CITY OF West Linn

Memorandum

Subject: Public Comments Received for DR-23-01

To West Linn Planning Commission
From Ian Brown (1968 6th Ave)
Audra Brown (1968 6th Ave)
Re DR 23-01 (1919/1949 Willamette Falls Drive), 10/4/23 meeting

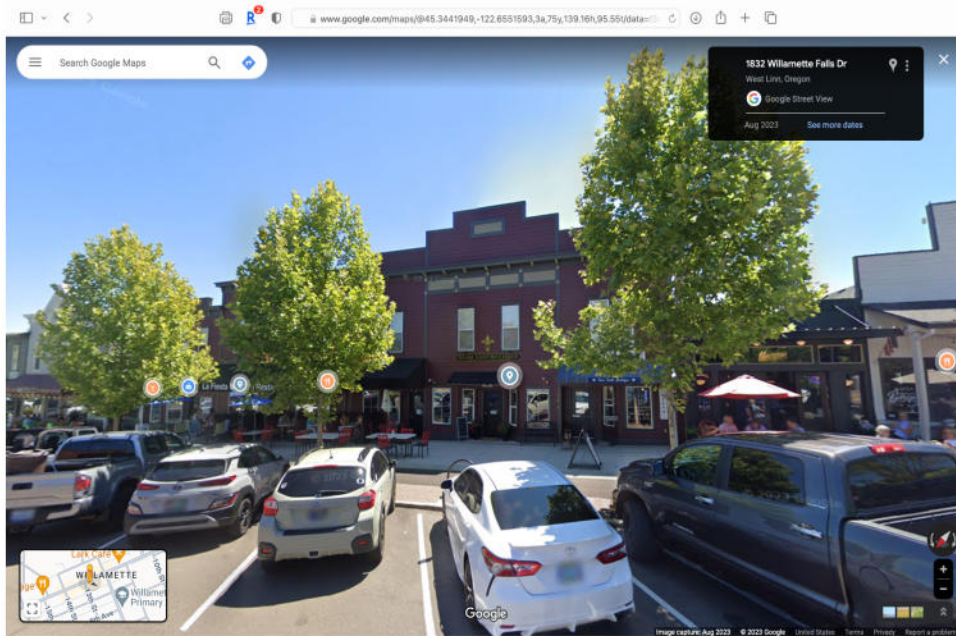
1849 Willamette Falls Drive is a modest example of an older local building with third-story space hidden behind a western false front.⁷ The third-story space is in a conventional "half-story" configuration, making use of the space under a gable roof. The false front has the appearance of a tall parapet rising from the second story. It has the same lap siding material, painted in the same color scheme, as the first and second story. It has no windows. It runs only along the side of the building that faces Willamette Falls Drive and joins no right angles. It steps down as the distance from the gable ridge line increases and plainly could not be the wall of a full third story. Because the false front faces only the street side of the building, a person viewing it at an angle off of center can easily see empty space behind it, creating the impression that there is no third story structure at all. The overall effect is to render the third story structure very difficult to identify from Willamette Falls Drive, 12th Street, or 13th Street.

The applicant's third-story structure is completely different. Rather than a street-facing false front that steps down with distance from a ridgeline, it has four straight walls joined by at right angles, creating the visually unambiguous appearance of a 25' by 100' box. Rather than using a half-story configuration with a sloping roof to minimize visibility, it has a flat roof to maximize space. Rather than being set back from the streets on the sides to minimize visibility, it is set at the edge of the second story on all three sides that are visible to the public. Rather than eliminating windows altogether from the street-facing side, it displays large sets of windows on the most prominent corner of the building, windows that clearly correspond to the second-story windows below. Unlike the third-story structure of 1849 Willamette Falls Drive, which does not appear to be a third story at all from three sides, the applicant's third-story structure is impossible to miss from the north, west, or south.

The comparison with 1849 Willamette Falls Drive does not support the application of criterion A. Rather, it shows that the applicant's alternative is not correct for the period architecture in the area.

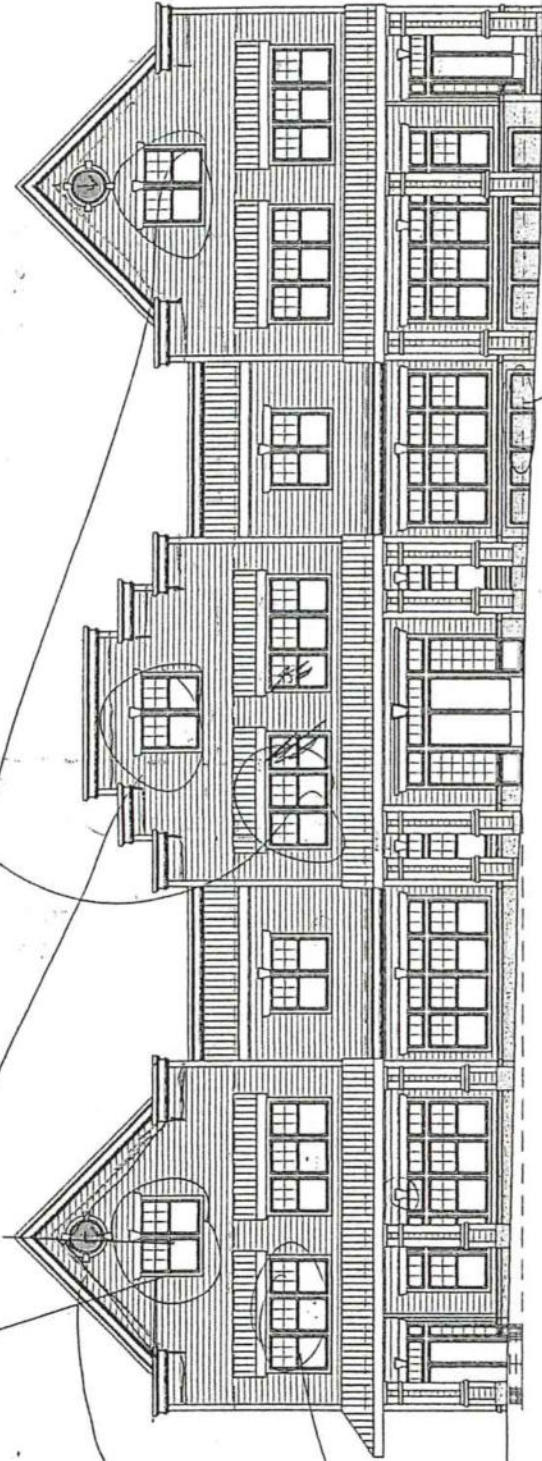
*All windows
not
double
sided*

*Specify
building materials*

*max 35'-
keep ht
down
45° okay
12/12*
